CHANGE ORDER BREAKDOWN -- WORKSHEET				
JOB NAME: Kronenwetter Well ARCH JOB NO: 2021.022 ELLIS JOB NO: 23061 CHANGE ORDER NUMBER: ES-08 DESCRIPTION: RFP 04 DATE: 05/14/25

CE #014 - RFP 04 - Modifications to Air Release Piping and Detention Tank Taps

Subject: Request for Proposal 04 – Air Release Piping Modifications and Tap Installations

WE ARE RESPONDING TO THE FOLLOWING RFP:	
RFP # :	04
Section:	N/A
Description:	Proposal 4 Review Response

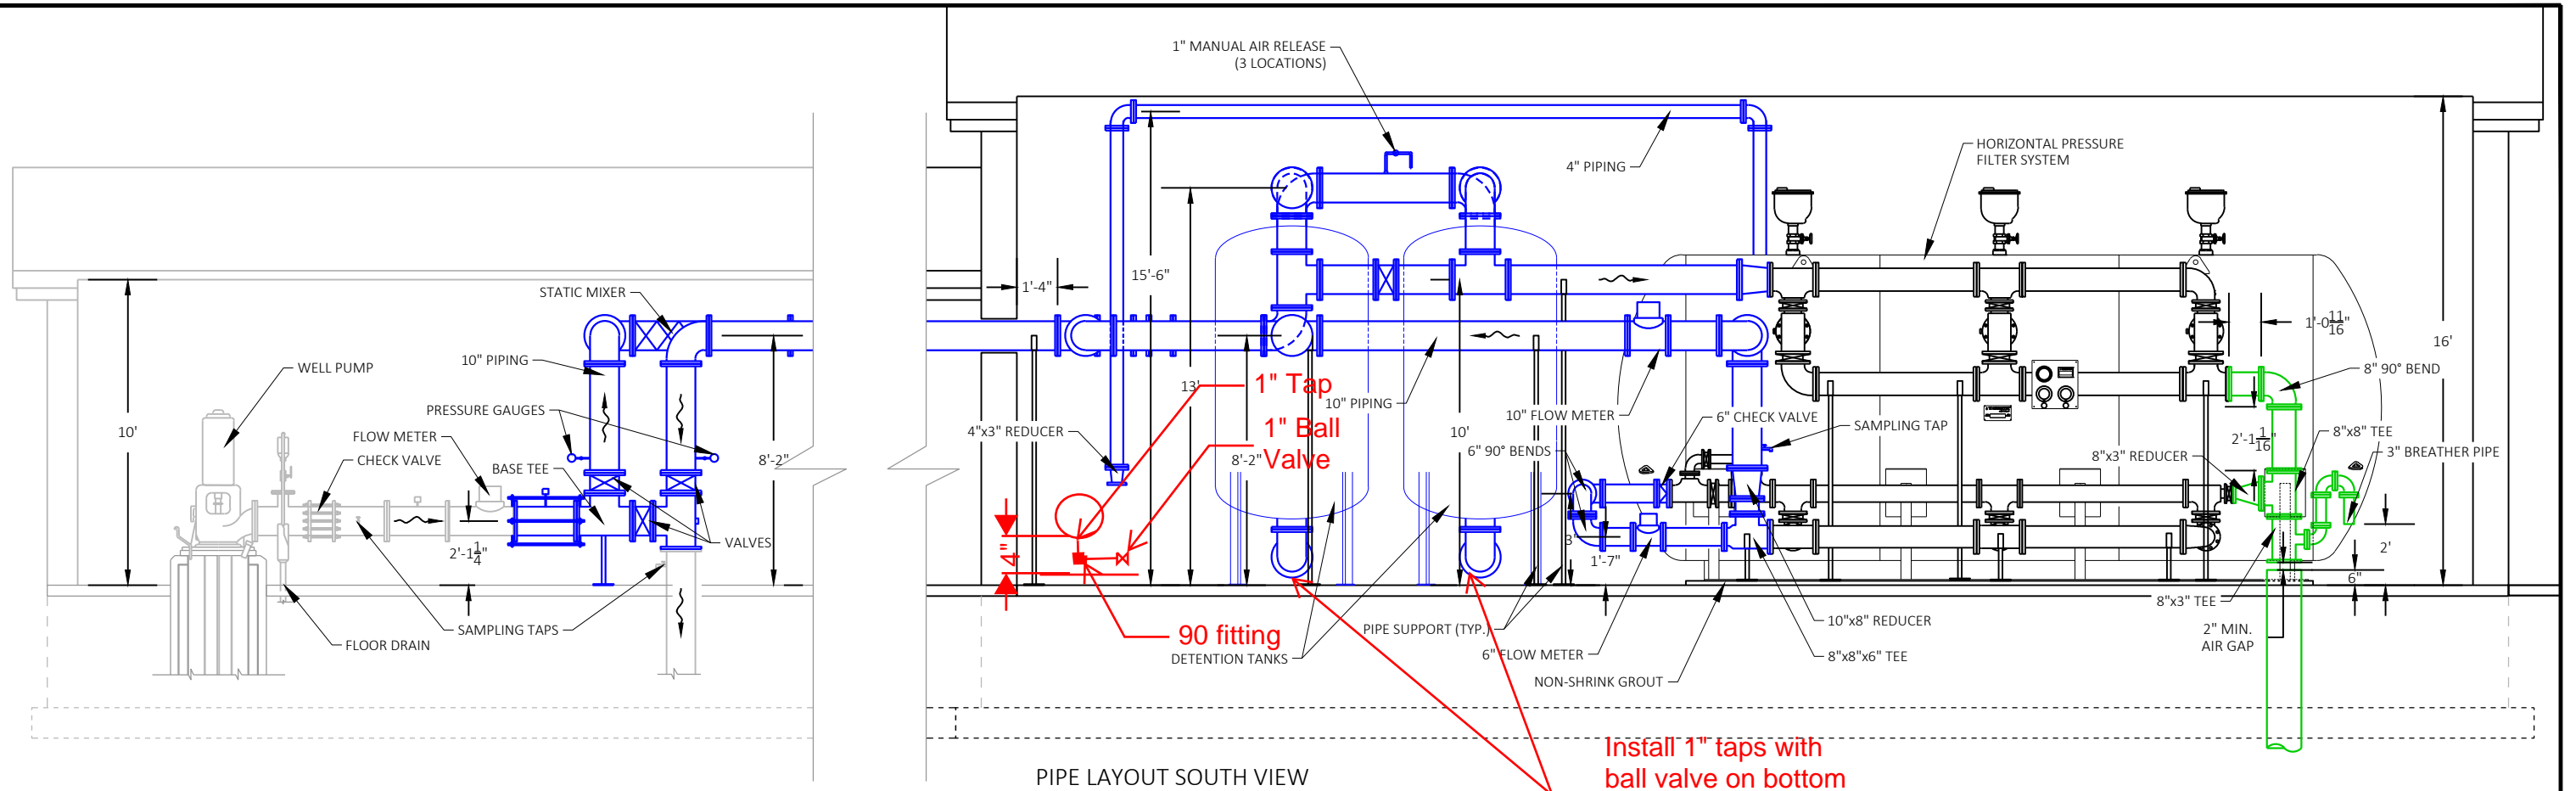
1. Modify the three (3) air release valve piping located on the top of the pressure filters from 1" PVC piping to 2" PVC Piping with #24 mesh.
2. Modify process piping between detention tanks to include two (2) 1" taps, 90 bend fittings and a ball valve.

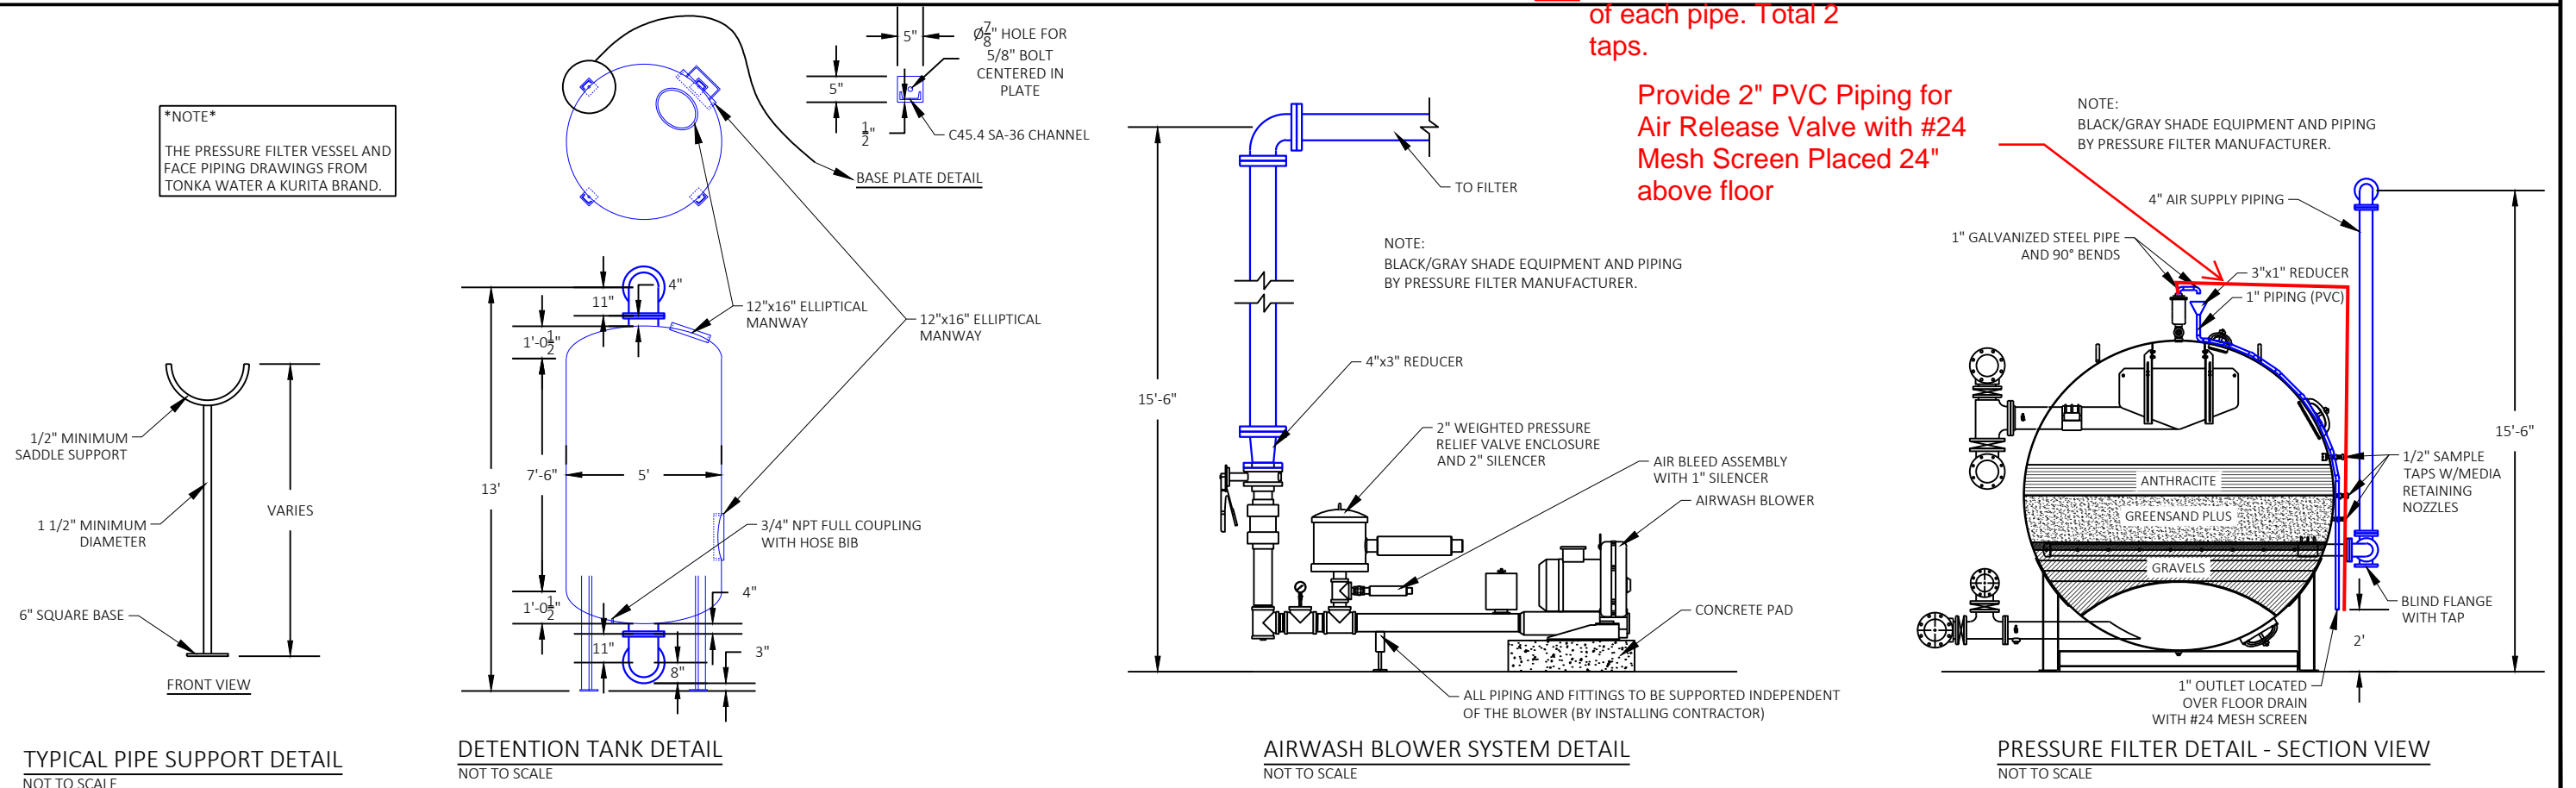
Install 1" taps with ball valve on bottom of each pipe. Total 2 taps.

Provide 2" PVC Piping for
Air Release Valve with #24
Mesh Screen Placed 24"
above floor
